**From:** Beltz, Terry  
**Sent:** Sunday, August 23, 2015 7:41 PM  
**To:** 'Michael K Scarpello'; hlkish@aep.com  
**Cc:** Alley, David; Tsao, John; Pelton, David  
**Subject:** Donald C. Cook Nuclear Plant, Unit 2 - Proposed Alternative to the ASME Code, Section XI, Repair Requirements  
**Attachments:** Socket weld.docx

**Subject:** Donald C. Cook Nuclear Plant, Unit 2 - Proposed Alternative to the ASME Code, Section XI, Repair Requirements  
**Sent Date:** 8/23/2015 7:40:44 PM  
**Received Date:** 8/23/2015 7:40:45 PM  
**From:** Beltz, Terry

**(c-1) Slip-On Flange [Note(3)]**

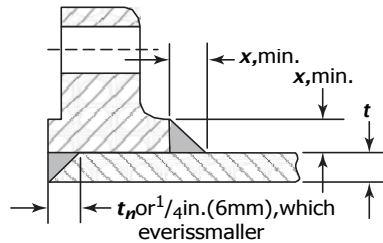
Item C-1 (two drawings on left) are slip-on flanges. Item C-2 (single drawing on right) is flange socket weld. Item C-3 is another socket weld. The August 23, 2015, application indicates the affected component is socket weld FW-17. However, based on the attached drawings, the drawing supplied in Section 7 of your application does not clearly represent a socket weld. This, at the very least, indicates that the I&M may require two alternatives from the code case: 1) a mechanism other than fatigue, and 2) apply socket weld code case to a weld that is not a socket weld.

Therefore, the NRC staff requires a better drawing of the subject component to clearly indicate if it is a slip-on flange or a socket weld flange. In other words, if this is a socket weld then a better drawing is requested. If it is not a socket weld, then you need to revise your request to reflect that the weld in question is not a socket weld and provide further discussion regarding that alternative to the code case.
